City of Portland, Maine - Building or Use Permit Application
 389 Congress Street, 04101 Tel: (207) 874-8703, Fax: (207) 874-8716

Permit No: 02-1167	Issue Date: NOV - 1 2002	CEL: 09B A004001
-----------------------	-----------------------------	---------------------

Proposed Project Description:
Construct a 12' Addition to rear of house. Expand Rear section to width of Porch and House
→ toward Rd not water

All Purpose Building Permit Application

(A)

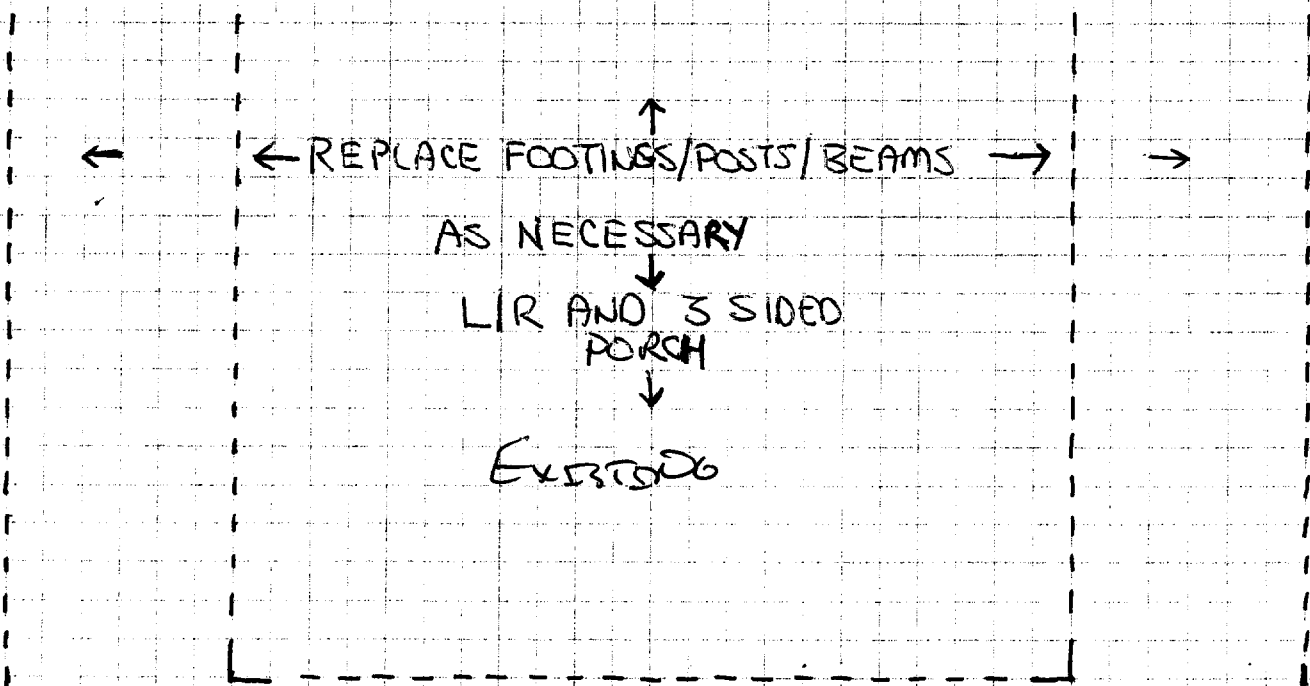
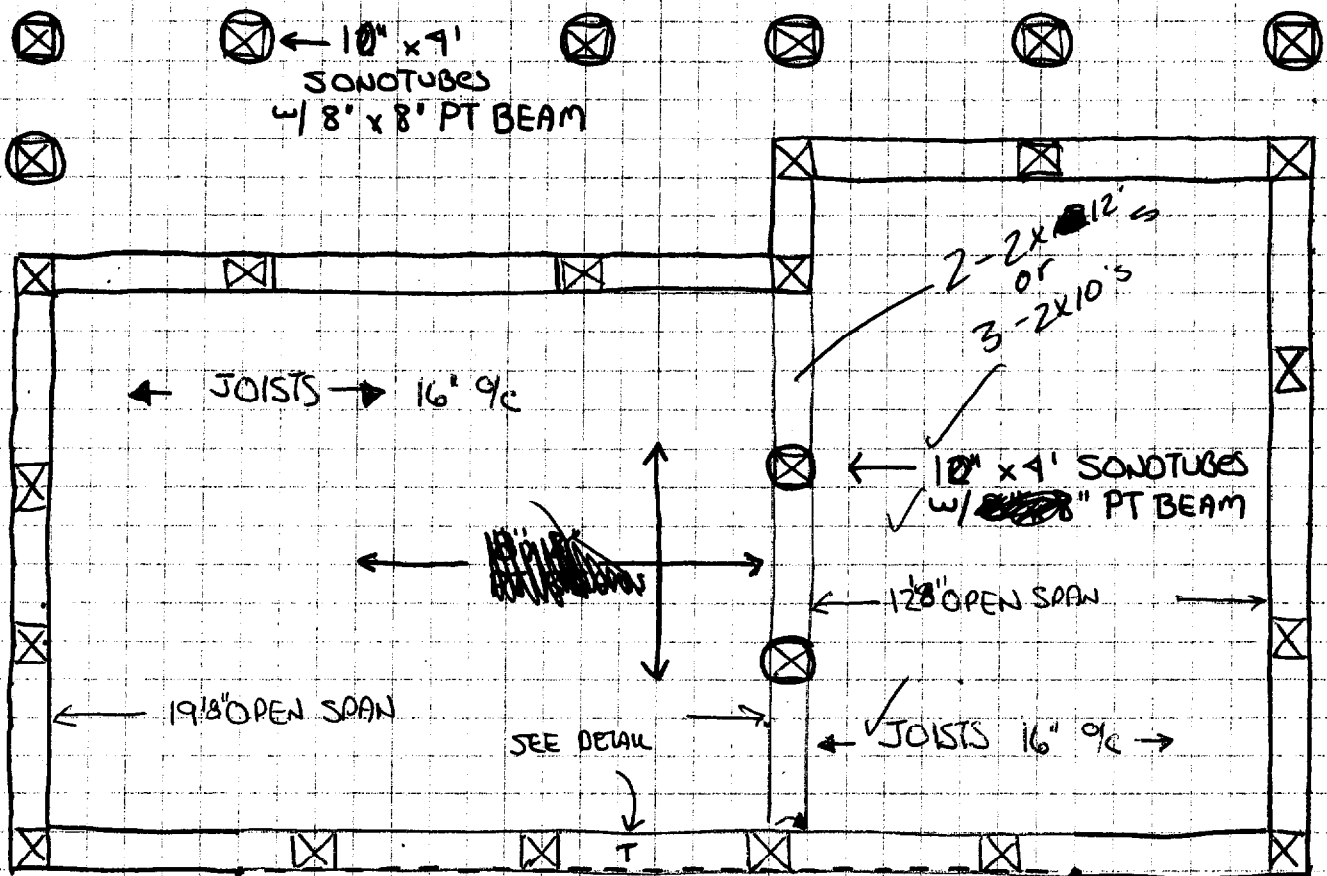
Comment Date	Comment	Name	Follow Up Date	Completed
11/01/2002	met w/owner - went over oil of the above - ok to issue permit.	tm		<input type="checkbox"/>
10/30/2002	need safety glazing in bath's, egress windows?, stair construction?, carrying beam sizes in bsmt and porch, rafters have to be 2"x8"s 16"oc, header schedule, and new stall specs. Called owner.	tm		<input type="checkbox"/>
